ADDENDUM NO. 6
TO GENERAL, MECHANICAL AND ELECTRICAL
ABERDEEN PUBLIC WORKS
MAINTENANCE BUILDING
ABERDEEN, SOUTH DAKOTA

Addendum Dated: March 27, 2026

Original Plans and Specifications Dated: February 20, 2026

2.2.B OVERHEAD COILING SERVICE DOORS; NON-INSULATED, INDUSTRIAL DUTY

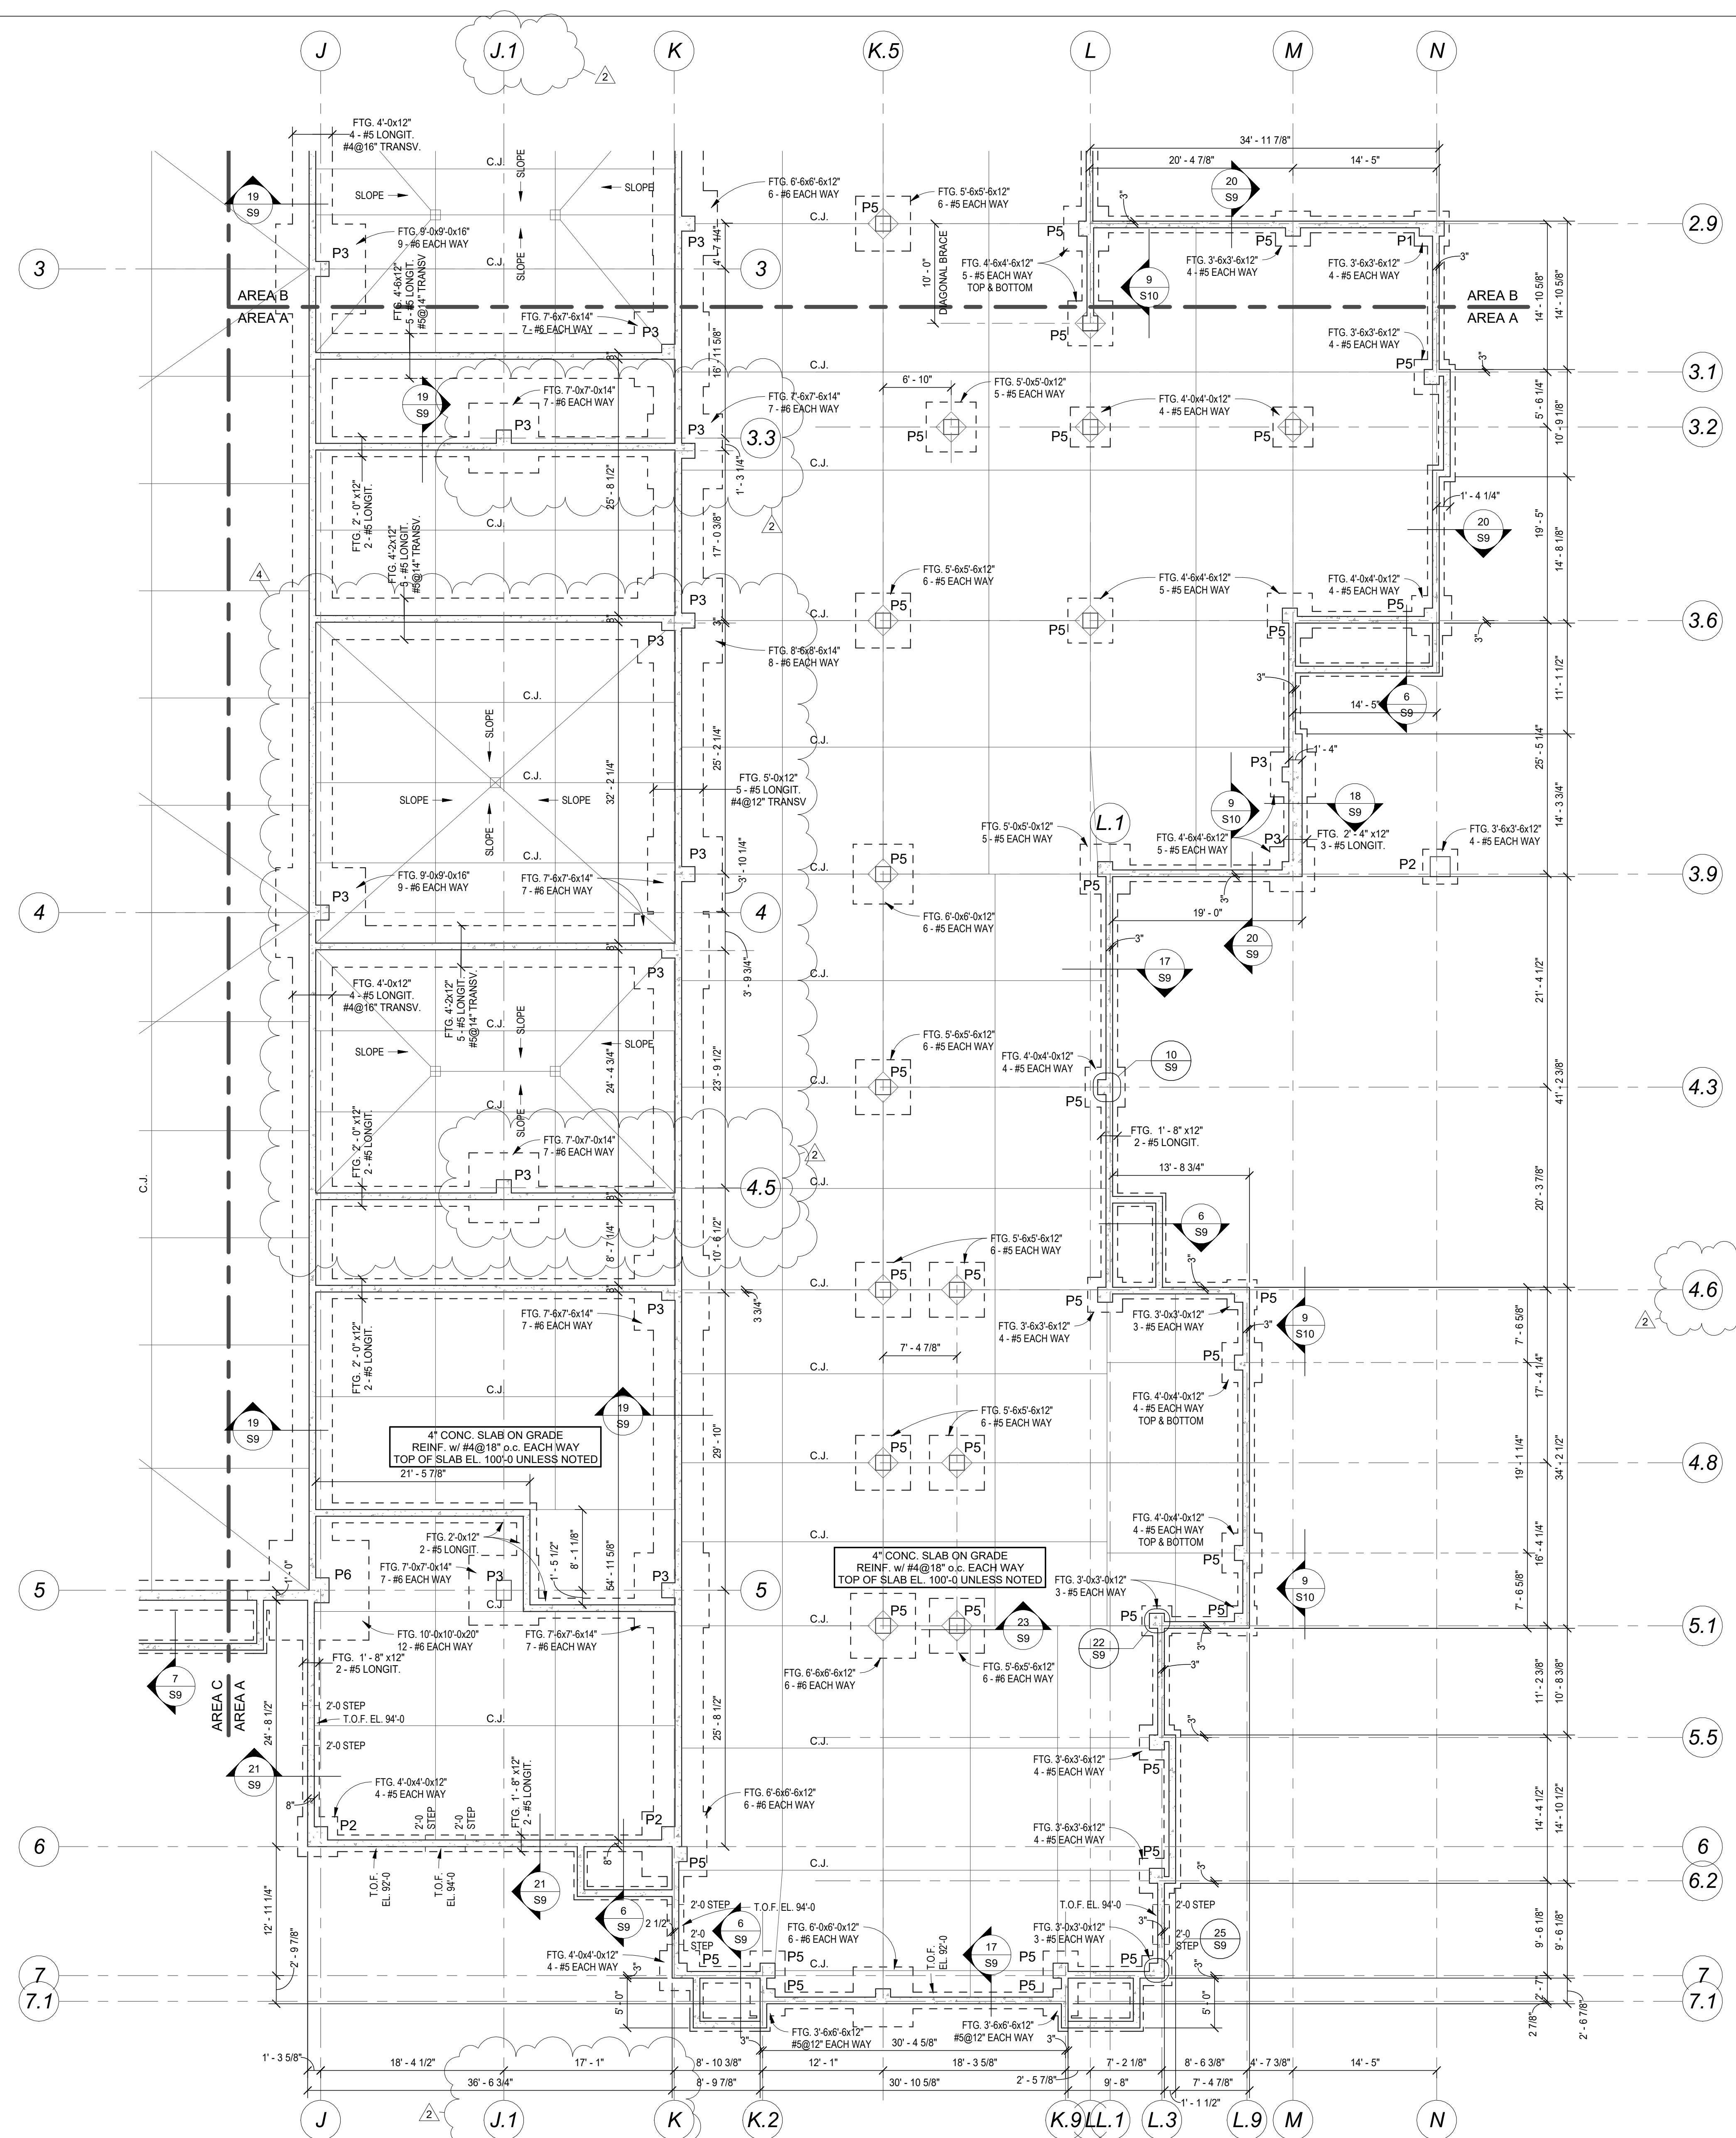
- 5. Section 08 33 00 – Overhead Coiling Doors
 - a) Add 2.2.B. Overhead Coiling Service Doors, non-insulated, non-fire rated, Industrial Duty - 203C, 212B (attached 2 pages).

1 FIRST FLOOR HVAC VENTILATION PLAN - AREA D
1/8" = 1'-0"

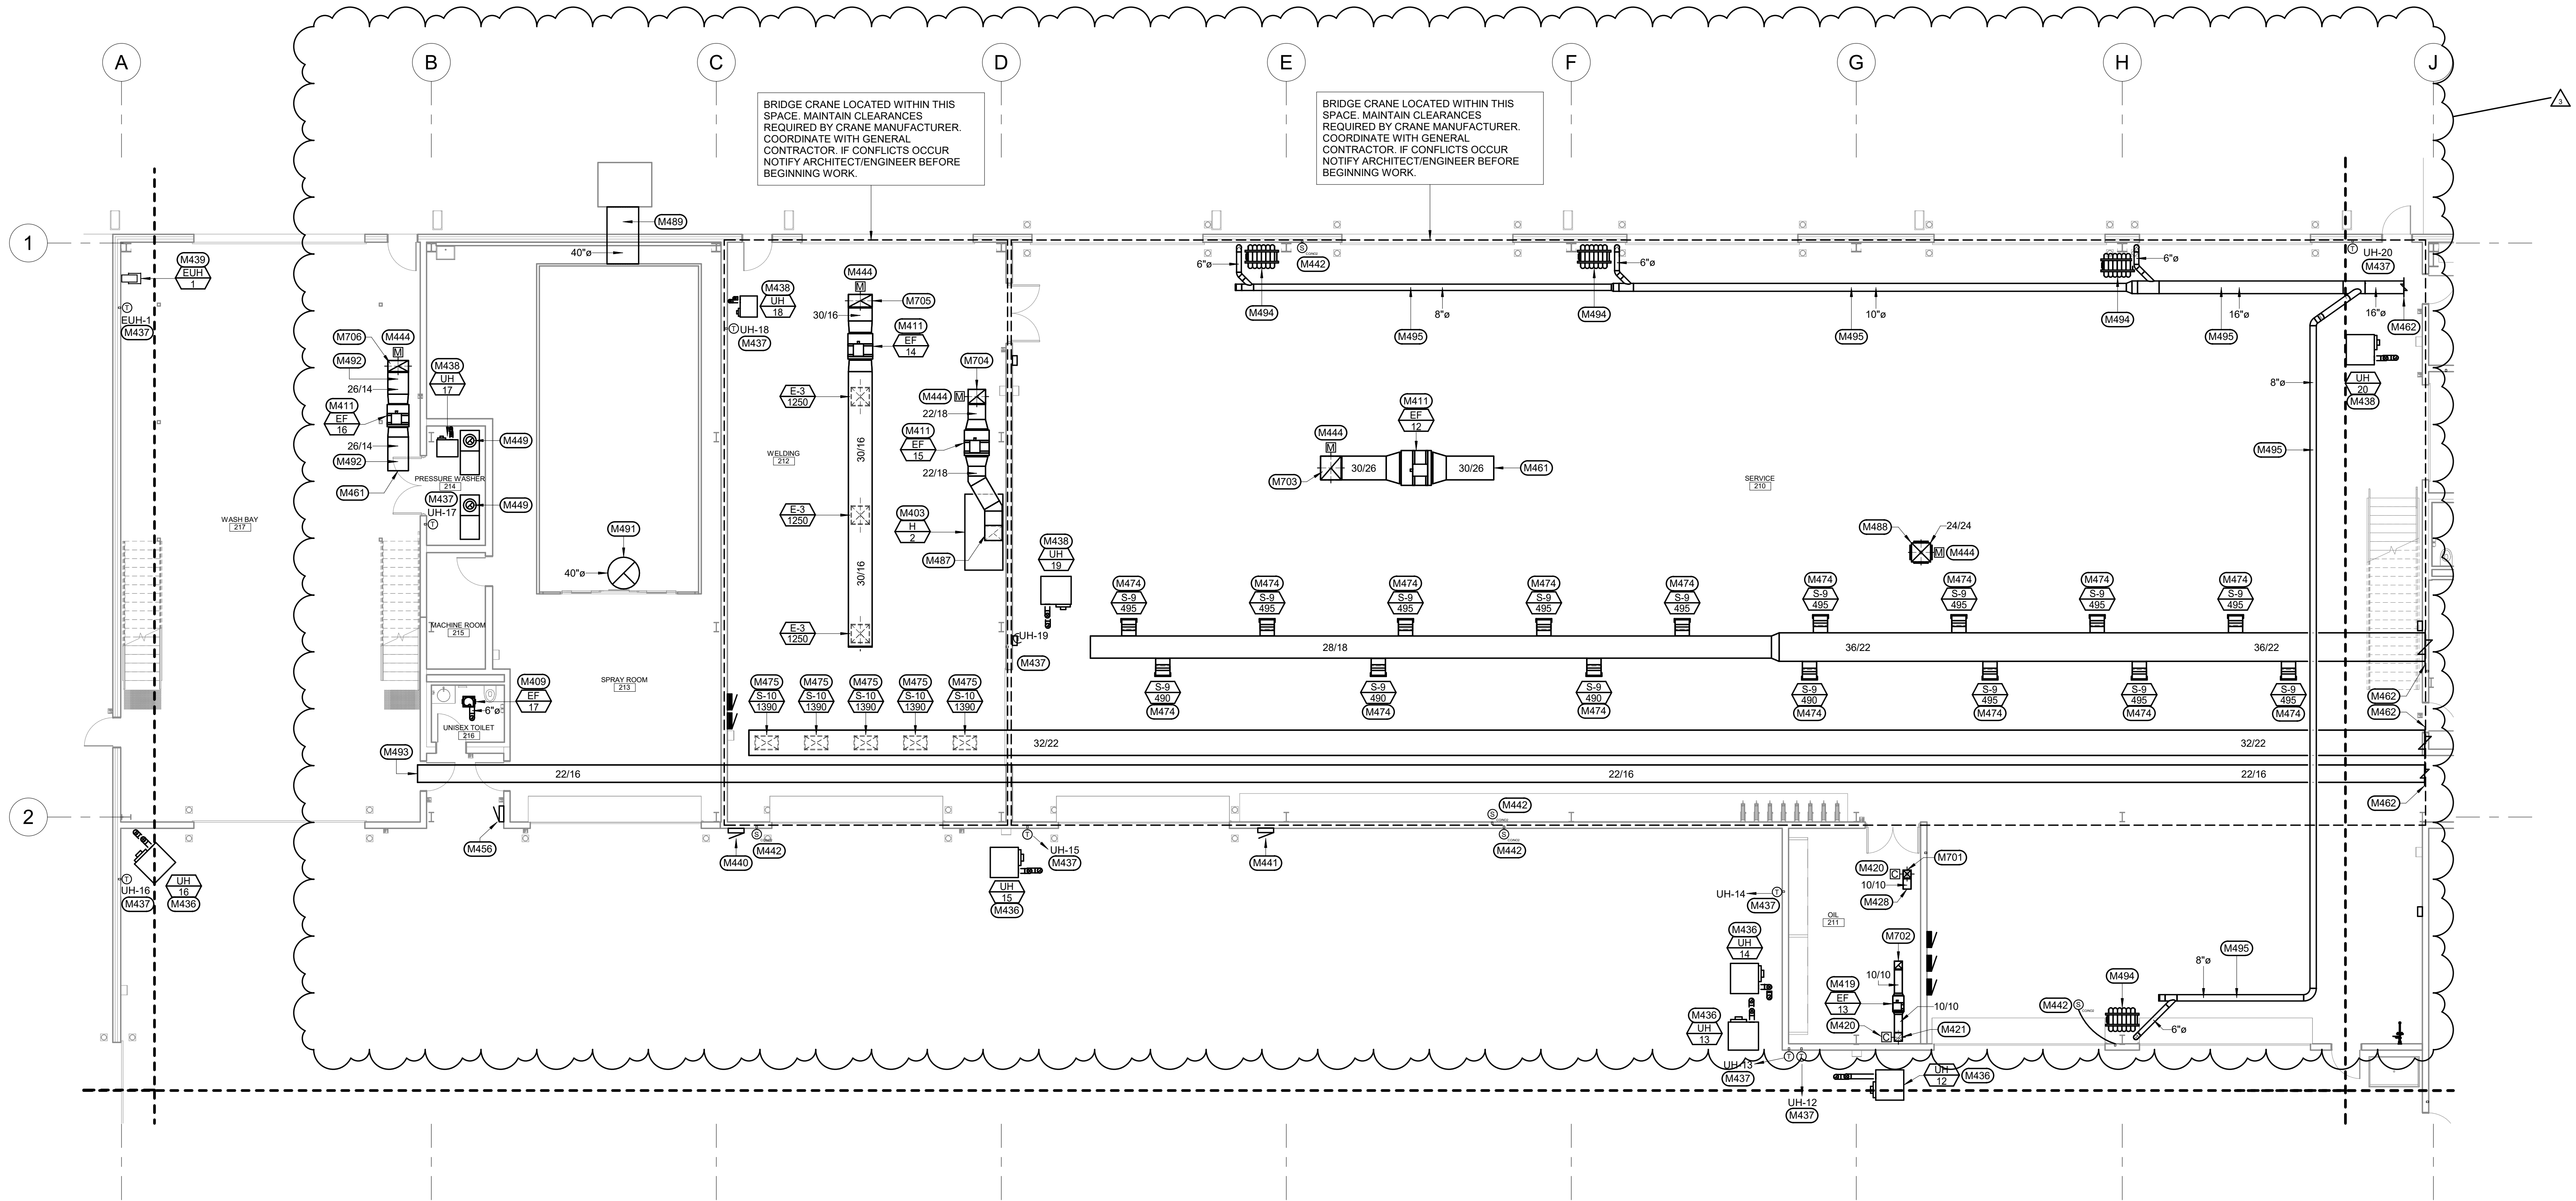
1. See attached sheet for the following revisions:
 - a. Air inlets and outlets and some ductwork were added in areas that were previously missing these items.
 - b. A large amount of notes added to the drawing to better clarify the drawings intent.

1 FIRST FLOOR HVAC PIPING PLAN - AREA D
1/8" = 1'-0"

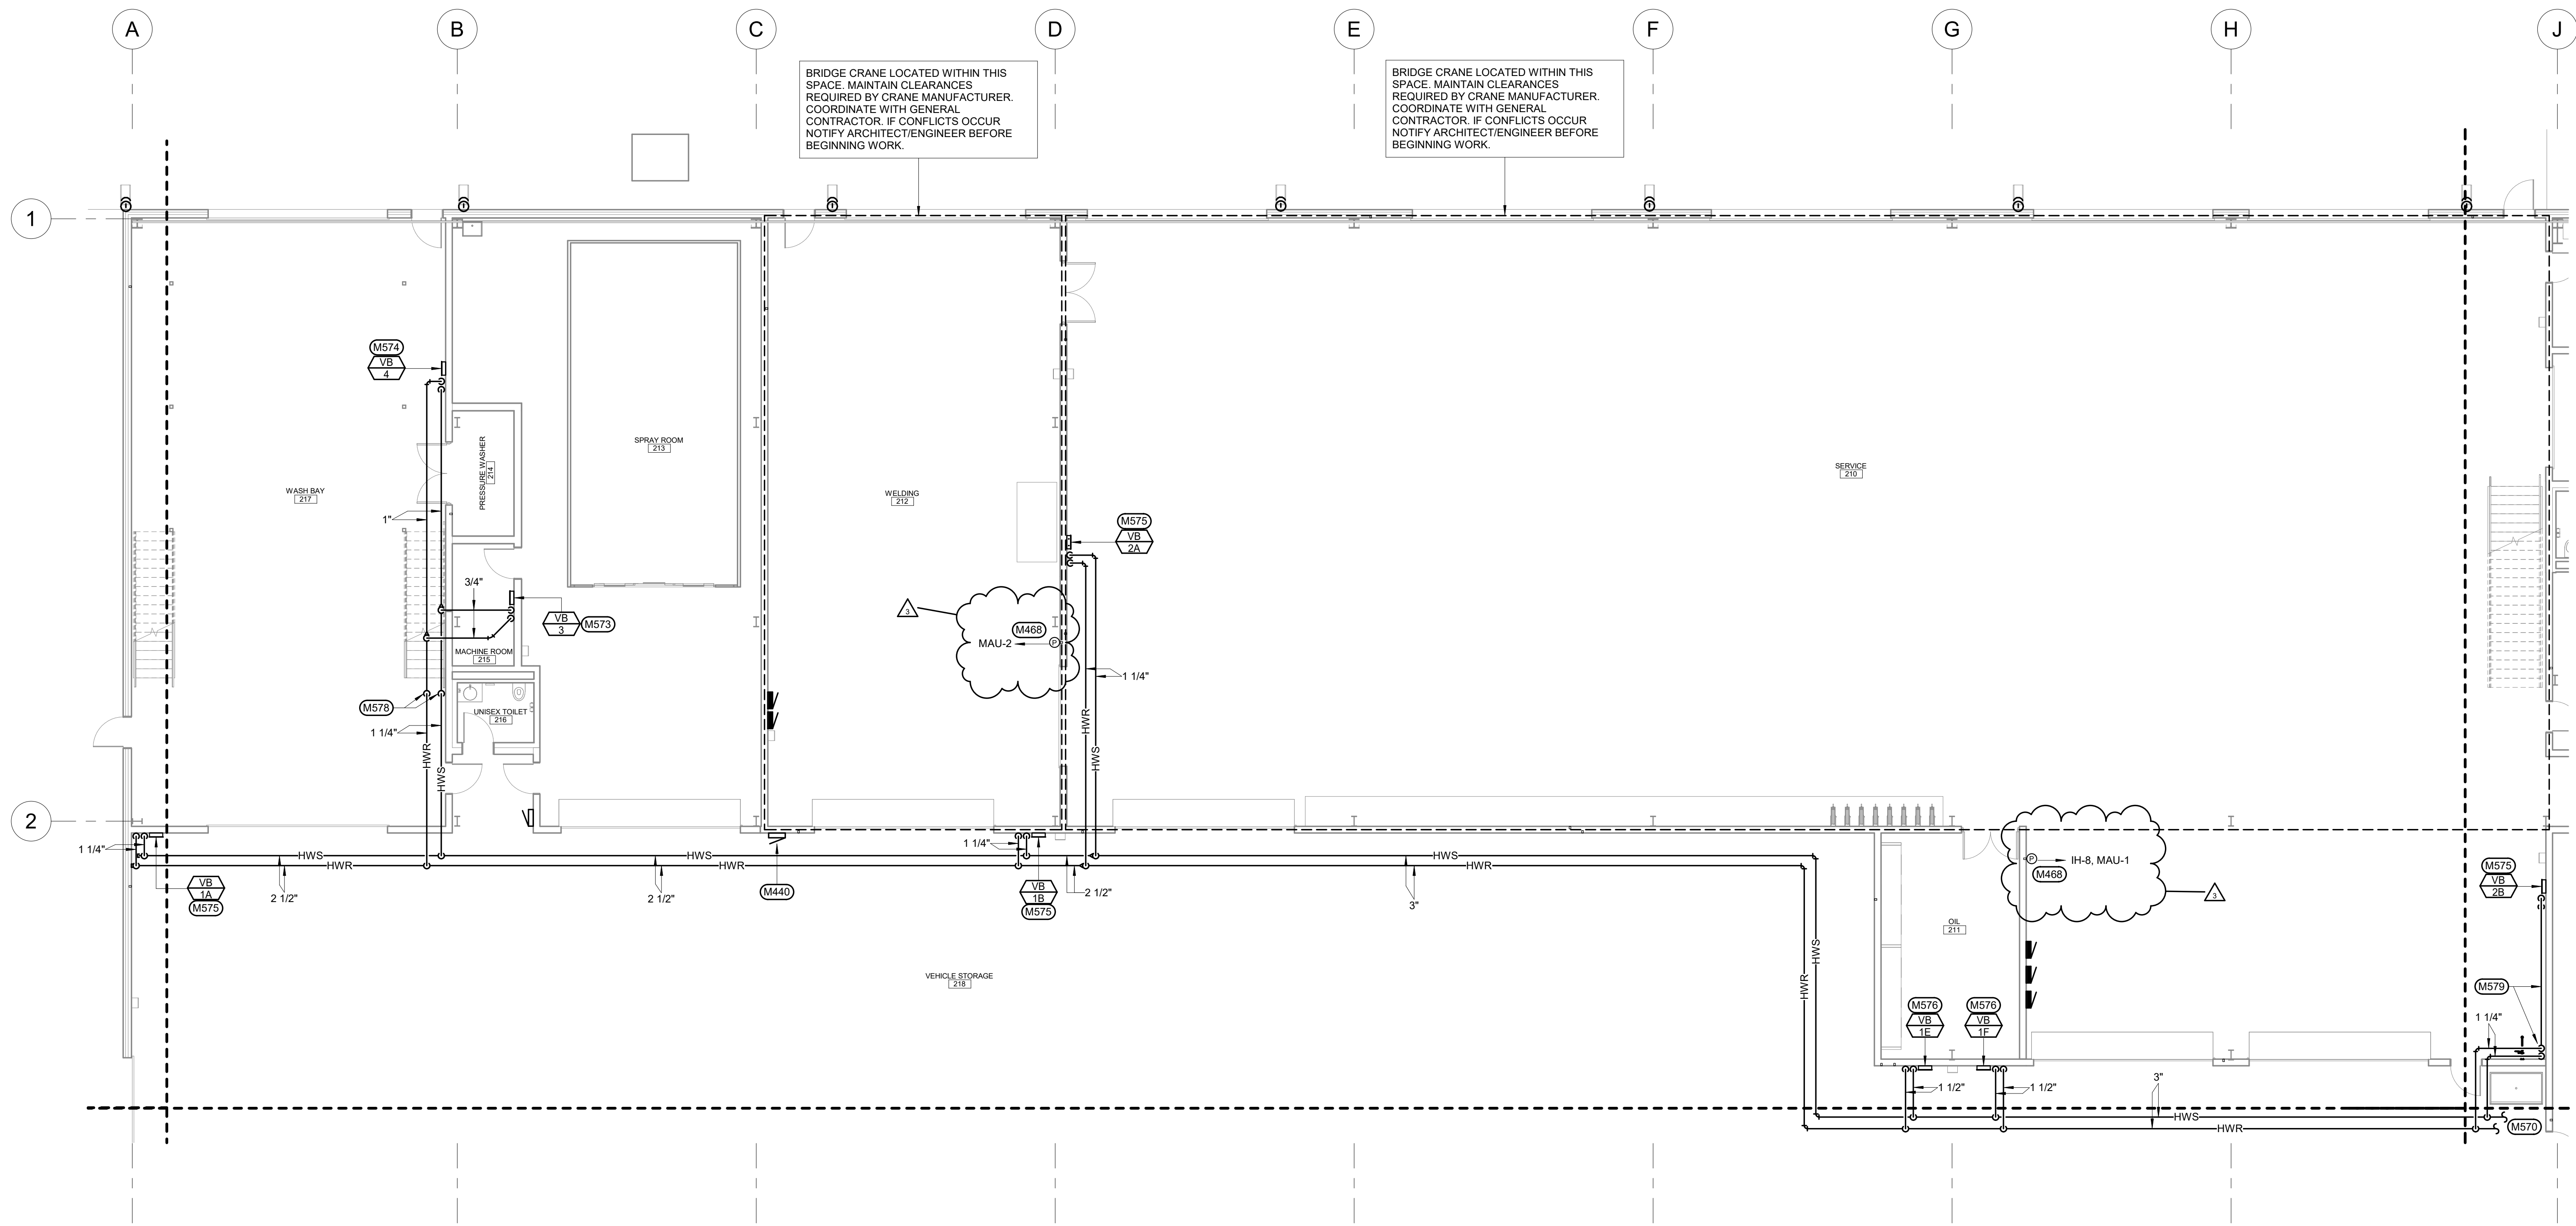
1. See attached sheet for the following revisions:
 - a. BAS pressure sensors added to Service 210 and Welding 212.
